Technical Information Bulletin

02-140

T680 Washer Reservoir Leak

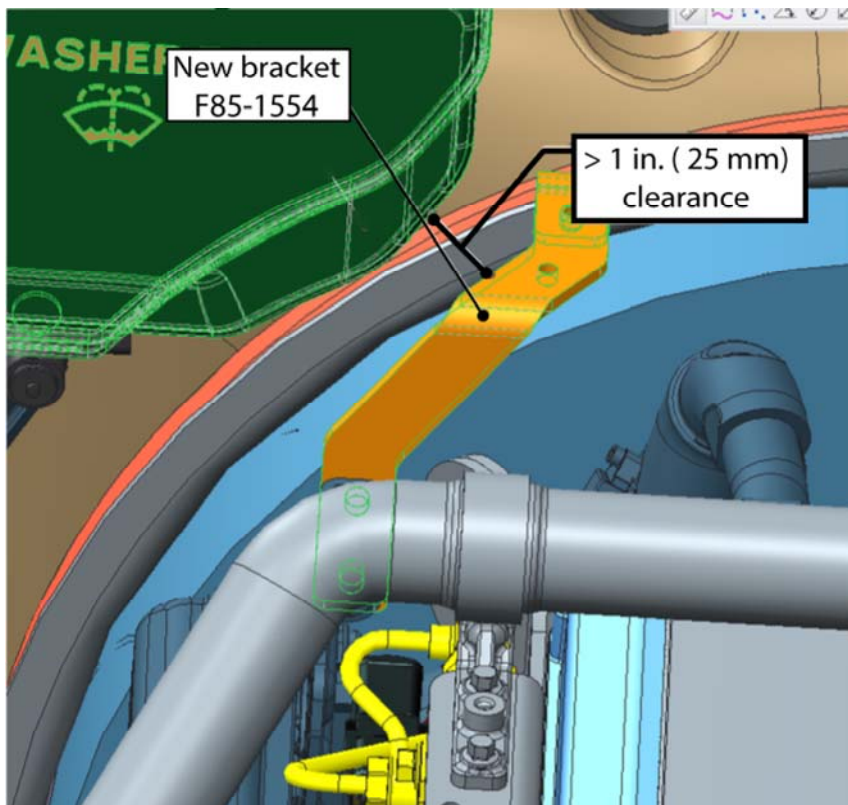
1. Confirm that the washer reservoir has a leak caused by the top drivers-side fan ring support bracket rubbing on the reservoir.

2. Remove the washer reservoir.
3. Remove the top drivers-side fan ring bracket.
4. Install the updated fan ring bracket.
5. Install the new washer reservoir.
6. Confirm there is at least 1 in. (25 mm) clearance between the bracket and the reservoir.
